PRIVATE PLAN MODIFICATION 50
HEARING REPORT
VOLUME 1
WAIHOEHOE PRECINCT
OYSTER CAPITAL

A NOTIFIED PRIVATE PLAN MODIFICATION TO THE AUCKLAND UNITARY PLAN BY OYSTER CAPITAL

Hearing Report for Proposed Plan Change 50: Waihoehoe Precinct to the Auckland Unitary Plan (Operative in part)

Figure 1 Neighbourhood parks (smaller circles) and Suburb parks (larger circles) proposed by PPC 48, 49 and 50 – showing walking catchments

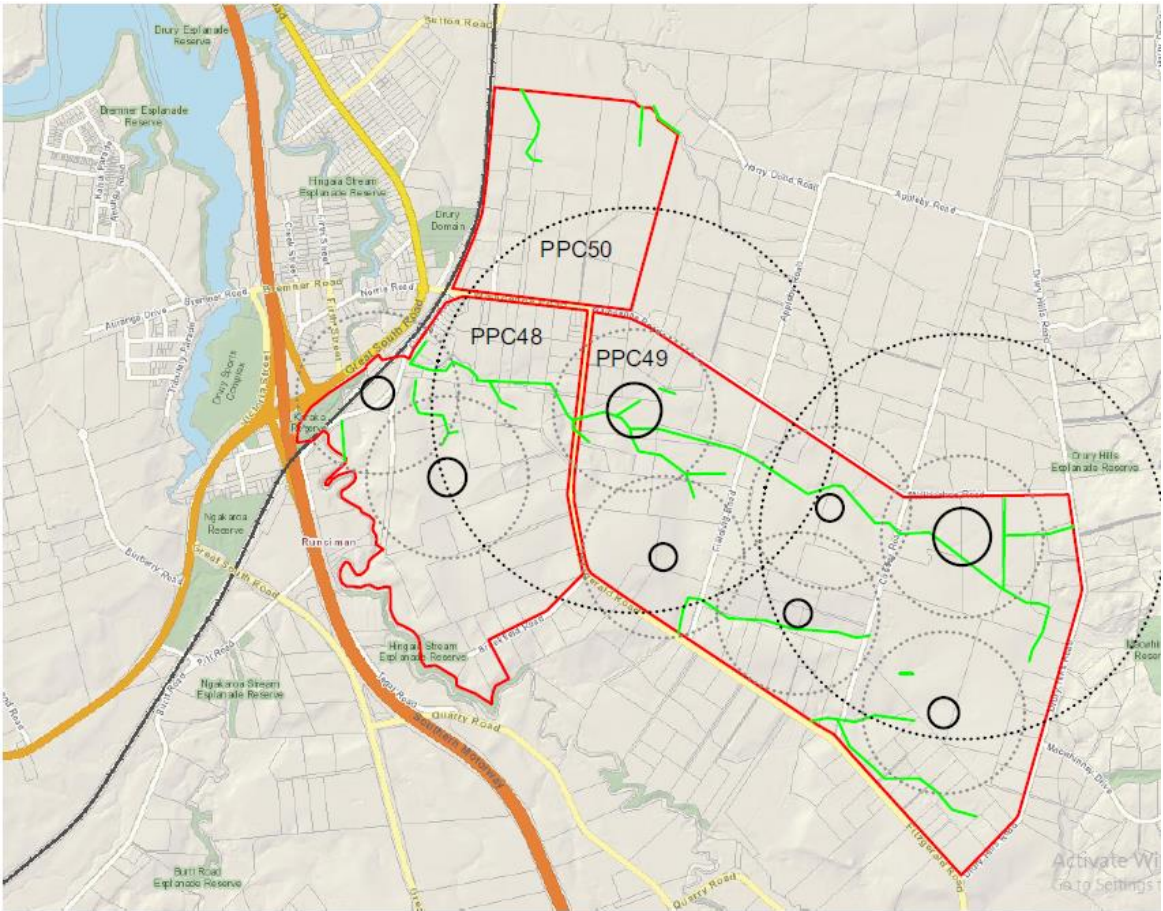
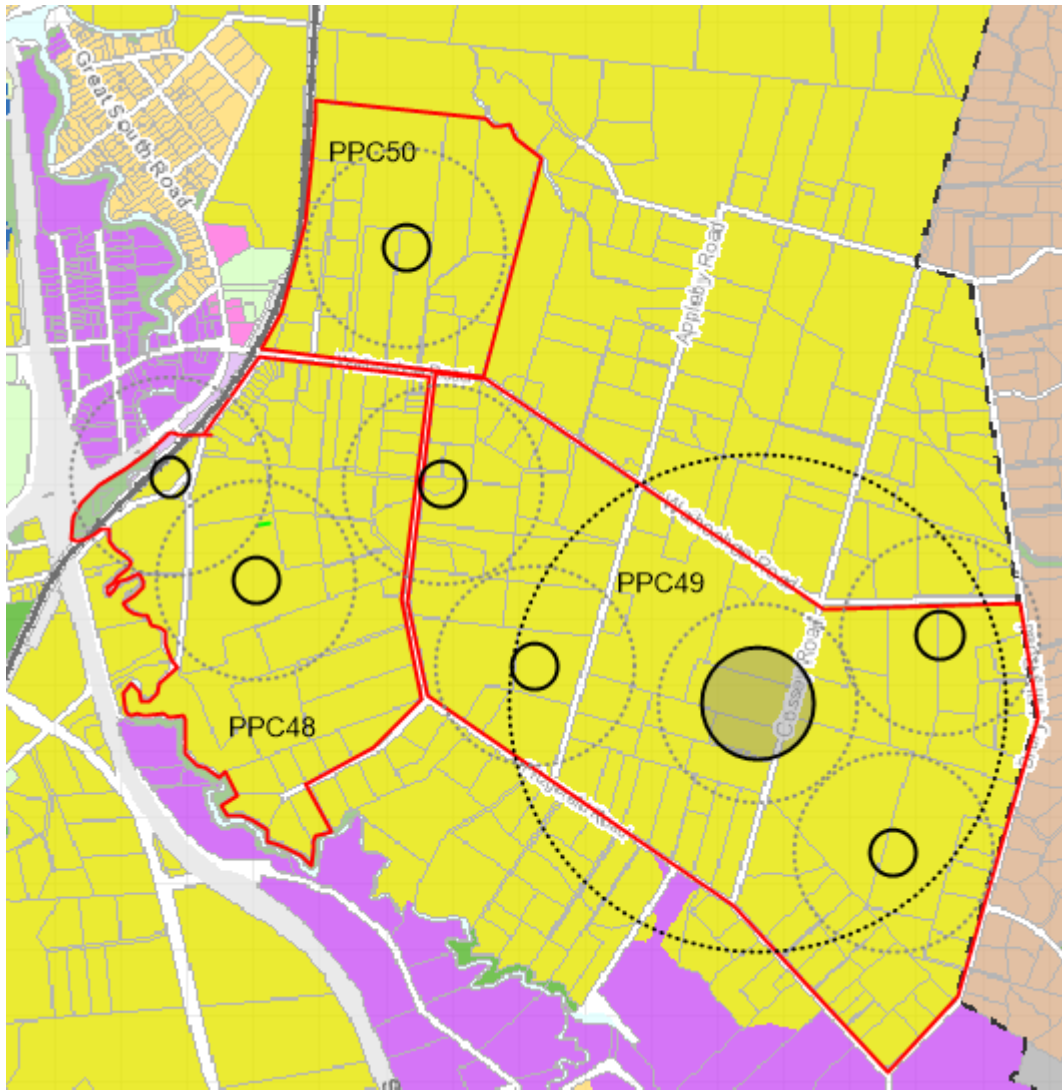
- 2.6 The lack of open space indicated on the precinct plan maps or within the urban design assessment or application documents means that there is the potential for an under provision of public recreational open space. The Open Space Provision Policy indicates that there should be a neighbourhood park located on the precinct plan and there is one shown on the Drury Opaheke Structure Plan (See figure 3). The submission received by Auckland Council has also identified an indicative location for the proposed local park which is supported (see figure 2). Council does not anticipate that local park land acquired for the purposes of playgrounds and kickaround areas would be provided within the flood prone land intended to be drainage reserves.

2.7 The urban design report by Holistic Urban Environments references the Council's Drury Opaheke Structure Plan but does not discuss the proposed need for a local park. The Figure 9 Opportunities and Constraints diagram on page 10 shows the indicative flood plain areas and streams but does not indicate a potential location for a local park. Figure 10 of the proposed structure plan on page 13 does not show any location for a local park but does provide for existing wetlands, green links/swales, drainage reserves, and park edge roads.

- 3.10 It is recommended that indicative locations of the local park and the drainage reserves as ecological corridors are shown on the precinct plan. It is recommended that in addition to Policy E38.3(18) and the suite of Parks acquisition policy documents that an appropriate location for local parks is determined as part of the plan change process to guide the implementation of Policy E38.3(18).

Table 4: Great South Road/Waihoehoe Road Intersection Assumptions

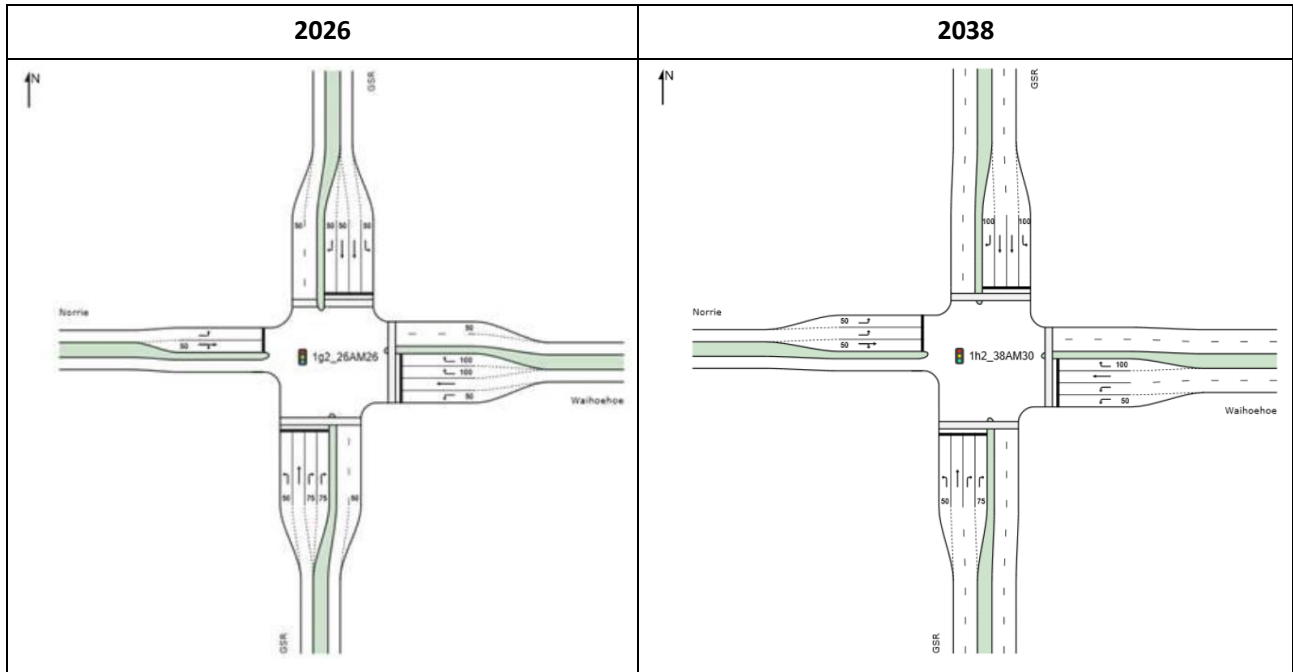
pedestrian/cyclist crossings on all arms of the intersection. While I appreciate that the design of the intersection is subject to further detail, the key concern relates to whether the current assumptions overestimate future capacity and therefore underestimate the potential effects and necessary mitigation.

Waihoehoe Road east of Fitzgerald

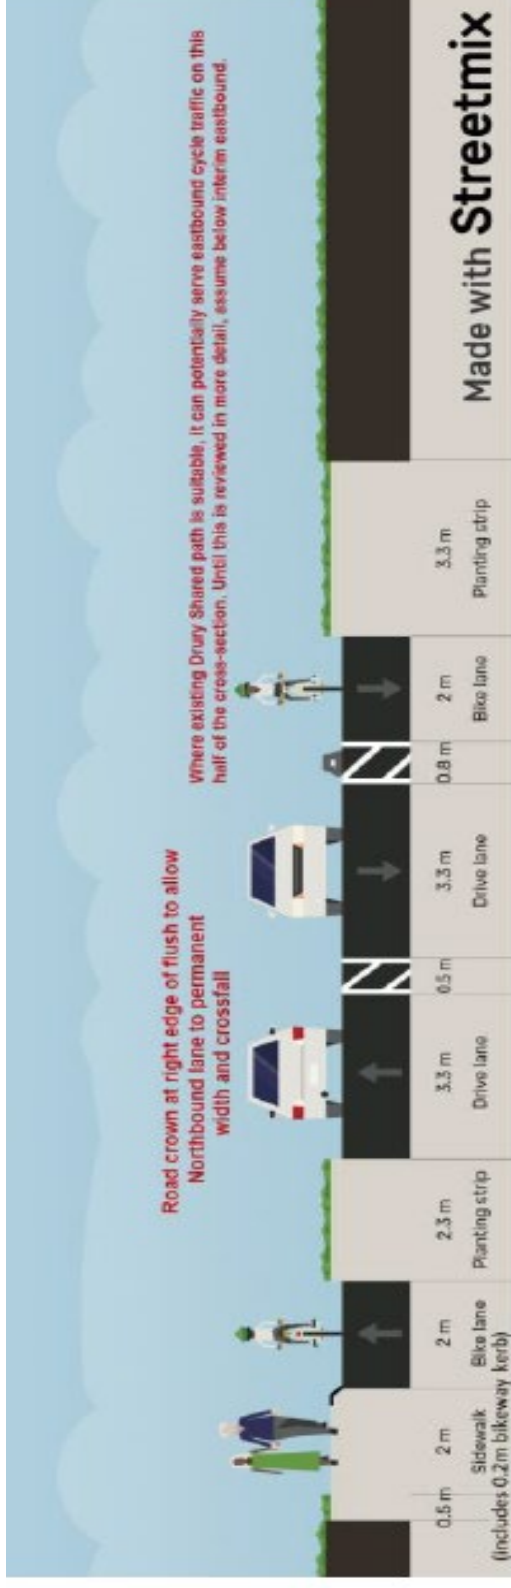
- Interim design for two lane arterial prior to NOR final position / design
- Design for the long term on southern side, as NOR proposes widening to the north
- Otherwise work within the existing 20m road corridor

Fitzgerald Road

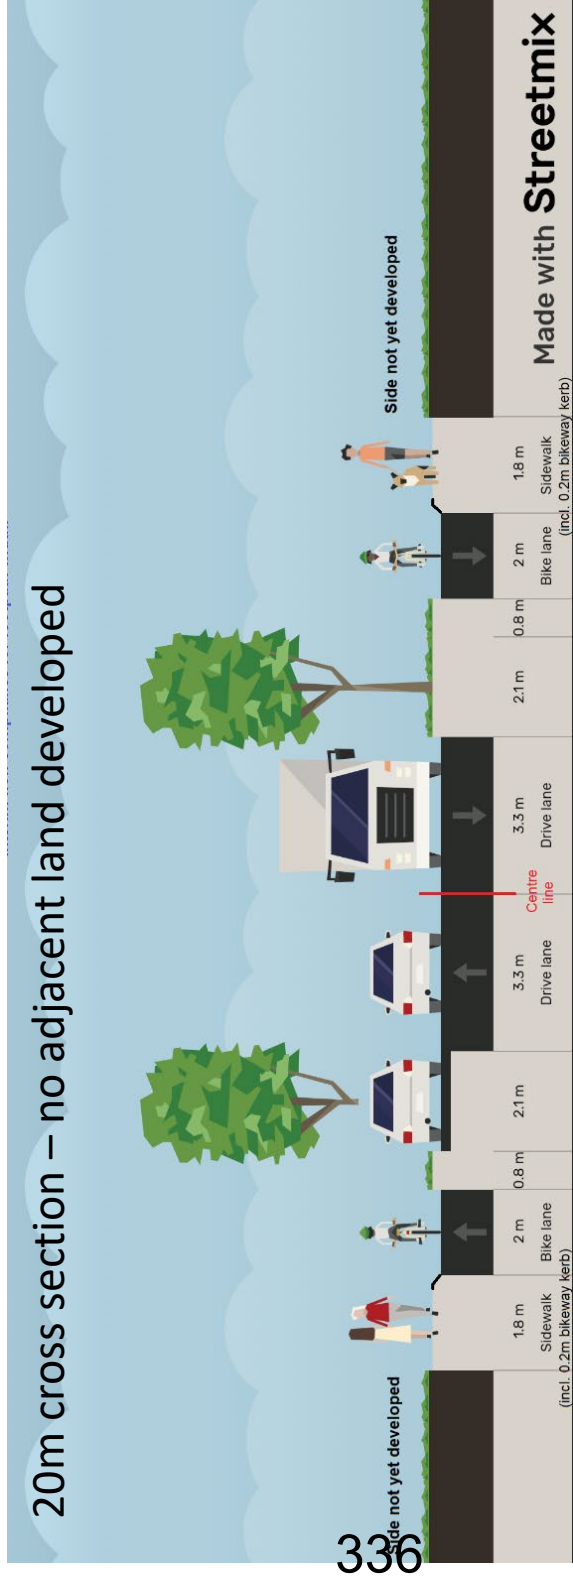
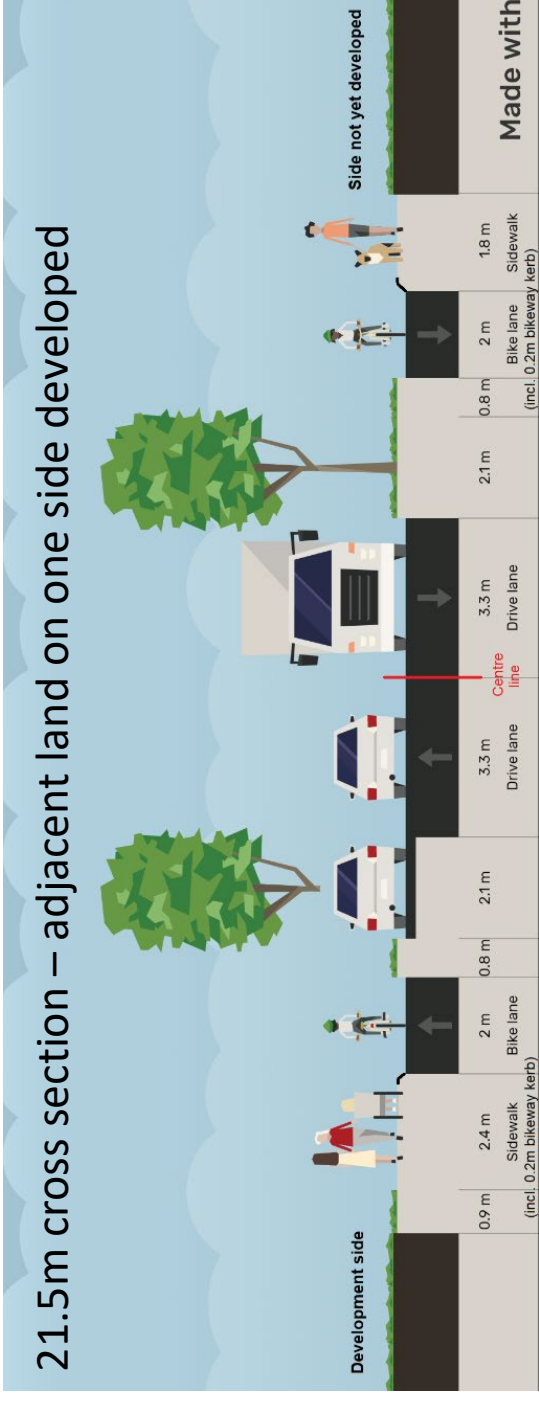
- Interim design for two lane collector
- Design for the long term where the land ownership allows
- Otherwise work within the existing road corridor
- Minor sub standard interim footpath to avoid rework when upgrading interim to long term.

Brookfield Road

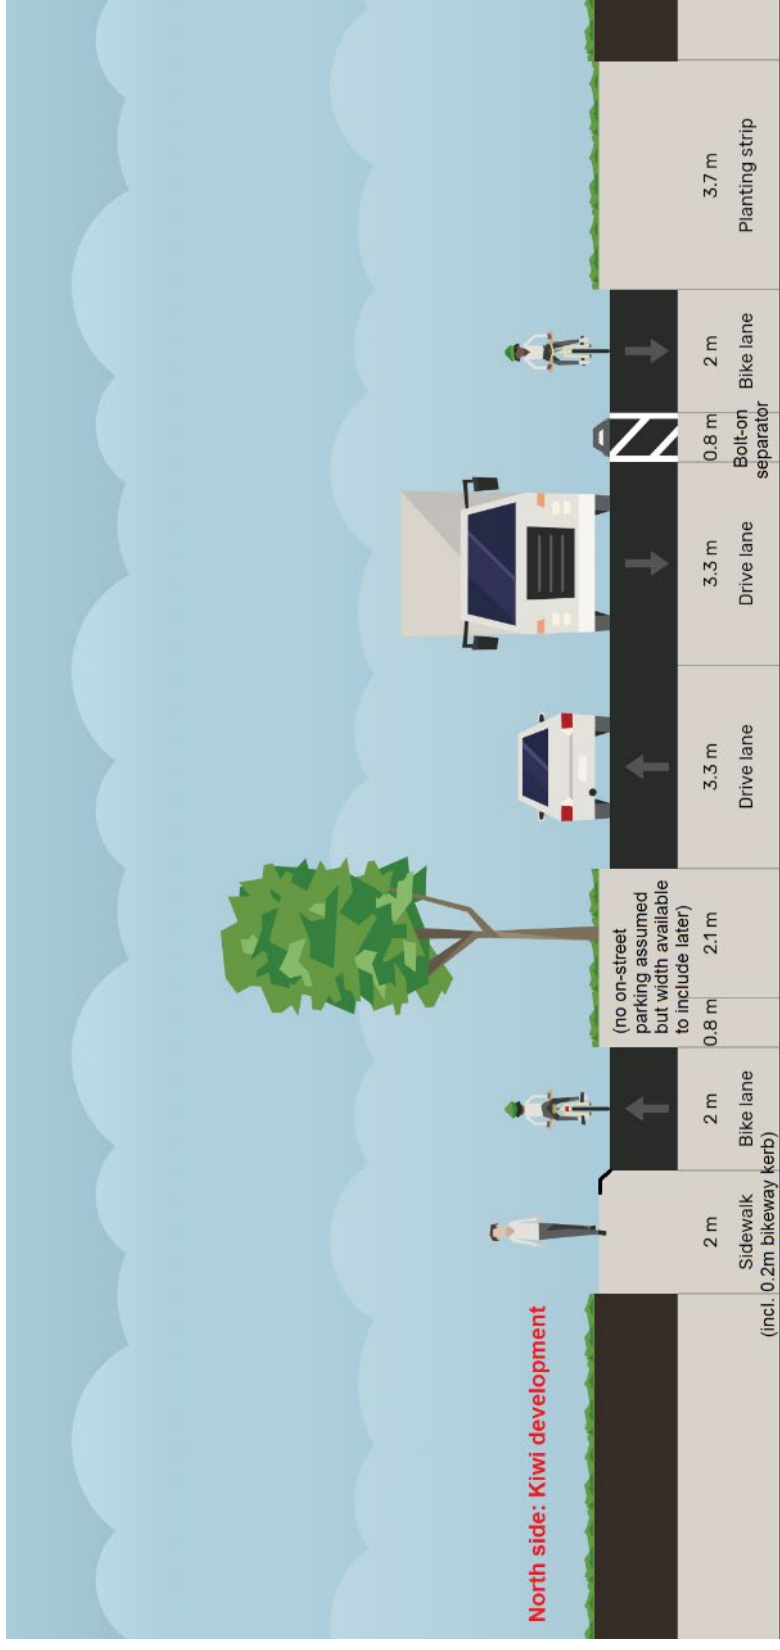
- Design for two lane road with active mode provisions
- Work within the existing 20m road corridor
